FHRG Review of New York Metropolitan Transportation Council (NYMTC) draft plan for the Hudson River Greenway Link

The Board of the Friends of the Hudson River Greenway in the Bronx (FHRG) has reviewed the draft report on the Greenway Link released by NYMTC and offers the following comments.

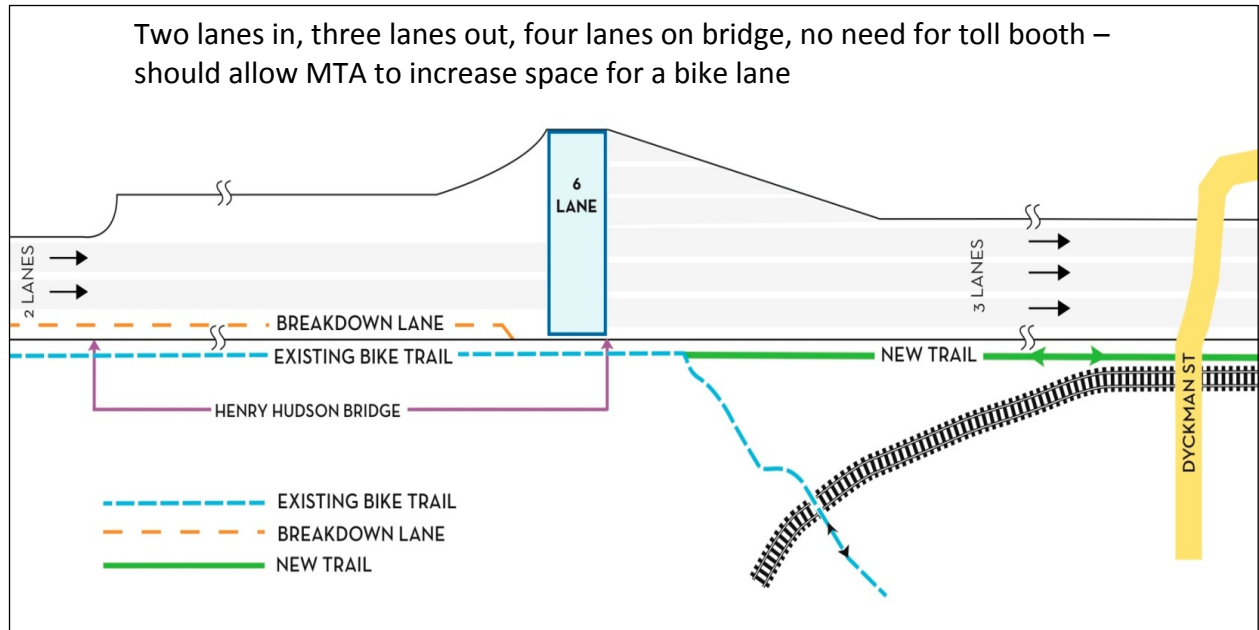
The draft report does not adequately define the Preferred Alternative as separate from the planned Staging of the implementation of the Preferred Alternative. We recommend the need for one map that more clearly defines the Preferred Alternative and a separate map for each of three implementation stages. The definition of the Preferred Route should be modified in three ways:

Inwood Park Link – Your existing definition of the Preferred Alternative does not address the major barrier created by the railroad tracks and the steep hills in Inwood Hill Park. We recommend that the definition of the Preferred Alternative include improvements at Dyckman Street that would eliminate the need to carry bikes over the railroad bridge and up the very steep incline. The final report should add a Link that defines a new bike route that will connect Dyckman Street with the lower level of the Henry Hudson Bridge, between the railroad and the western edge of the southbound lane, following the contour of the southbound lane. This alternative route eliminates the the conflict in Inwood Park between the bikers and other users of the Park. Further, it is likely that this Greenway Link can be built within the Highway right of way. As an interim measure, the report should consider modifying the trail as it goes up the very steep incline, changing it to a switchback trail. We provide detail below and have included this change on our recommended version of the Preferred Alternative map to be included in the final report.

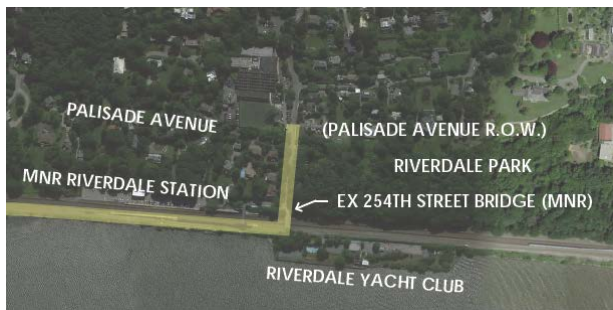
When the report is discussing Kappock Avenue, it provides details in the form of section drawings with measurements. For example,

This type of detail is provided for a number of the Street Links. However, it is missing for Palisade Avenue (both north and south of 254th Street), 261st Street and Riverdale Avenue. Even more

importantly, it is missing for the off-street parts of the trail. We recommend that cross sections with measurements be developed and presented for the following Links: through Riverdale Park between Spaulding Lane and 254th Street, through the park at the connection between Palisade Avenue and the waterfront at 232nd Street, Riverdale Park Waterfront Link and the North Riverdale Waterfront Link. The two waterfront Links should show the area from Track 4 to the water.

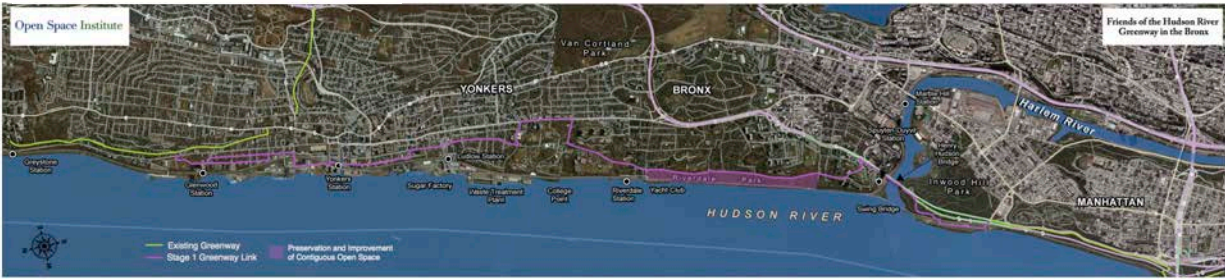
The report should address Track 6. It is a major feature of the waterfront area that is considered for the Greenway route. We understand that Metro-North does not want to abandon Track 6, but it significantly affects the design and cost of the waterfront part of the Greenway route. The non-

electrified track is not used except to occasional park work cars that could be parked elsewhere. It is 5 miles long and must be realigned to accommodate the Greenway Link. The report should assess the impact of removing part or all of Track 6 on the cost of the plan? We believe this information is already available to NYMTC and we estimate that the elimination of Track 6 could save tens of millions of dollars.

Stage 2 Implementation

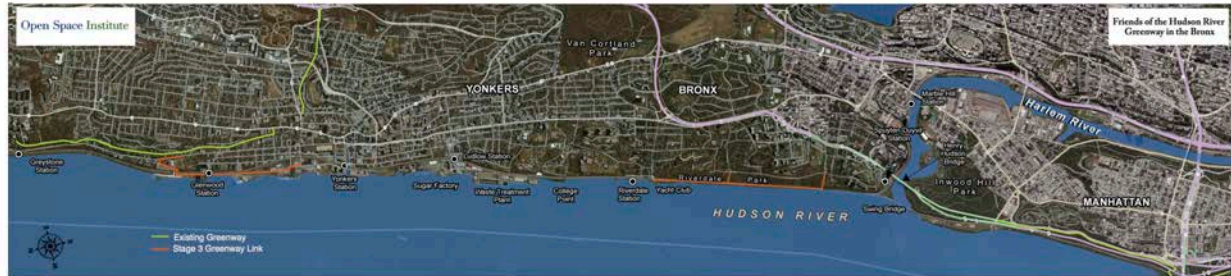
- Stage 2 – This Stage will provide an improved connection with the Henry Hudson Bridge, the permanent improvement on the Bridge, access to the waterfront and protection of the open space between the Riverdale Station and the Yonkers streets:
 - Inwood Park Alternative – new trail west of the highway and east of the railroad tracks, that hugs the southbound lane of the Henry Hudson Highway following the grade of the highway up to the HHB
 - Cantilever off the west side of lower level of bridge
 - Build the 254th Street transition from the Yacht Club Bridge to the railroad ROW (requires a new ramp and purchasing a small piece of land from the Yacht Club)
 - Build the Greenway on the railroad ROW between Riverdale Station and Fernbrook Street
 - Purchase easements from the College of Mount Saint Vincent/Sisters of Charity and the Hebrew Home

We request that the engineering, legal and regulatory work begin promptly after the Greenway Link plan is approved. We estimate that the pre-construction work can be completed in three years and that the construction can be completed in two years – a total of five years.
